REQUEST FOR COUNCIL ACTION

AGENDA SECTION:	ORIGINATING DEPT:	ITEM NO.
PUBLIC HEARINGS	PLANNING	E-9
ITEM DESCRIPTION: General Development Plan #213 by Americana Realty to be known as Americana Realty. The applicant is proposing to develop approximately 9.5 acres of land with single family attached dwellings. The property is located along the west side of Bamber Valley Road SW, north of Mayowood Lane SW and south of the Zumbro River. A Zoning District Amendment is being considered concurrent with this application.		PREPARED BY: Brent Svenby, Planner

August 11, 2003

General Development Plan #213 by Americana Realty to be known as Americana Realty. The applicant is proposing to develop approximately 9.5 acres of land with single family attached

Revised General Development Plan #213 by Americana Realty to be known as

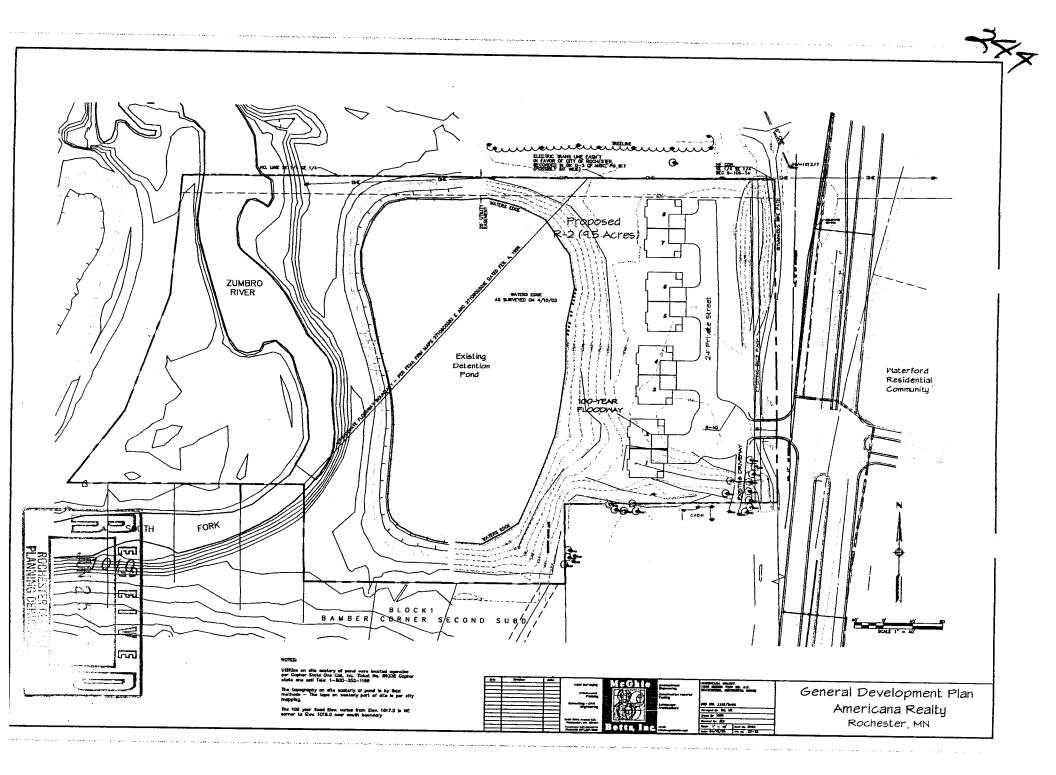
With regard to the above noted project plan, the fire department has the following requirements:

1. An adequate water supply shall be provided for fire protection including hydrants properly located and installed in accordance with the specifications of the Water Division. Hydrants shall be in place prior to commencing building construction.

- Streets and roadways shall be as provided in accordance with the fire code, RCO 31 and the Zoning
 Ordinance and Land Development Manual. Emergency vehicle access roadways shall be
 serviceable prior to and during building construction.
 - Dead ends in excess of 150 feet shall be provided with an approved area for turning around fire apparatus. See enclosed document for approved turnaround layouts.
- 3. All street, directional and fire lane signs must be in place prior to occupancy of any buildings.
- 4. All buildings are required to display the proper street address number on the building front, which is plainly visible and legible from the street fronting the property. Number size must be a minimum 4" high on contrasting background when located on the building and 3" high if located on a rural mail box at the public road fronting the property. Reflective numbers are recommended.
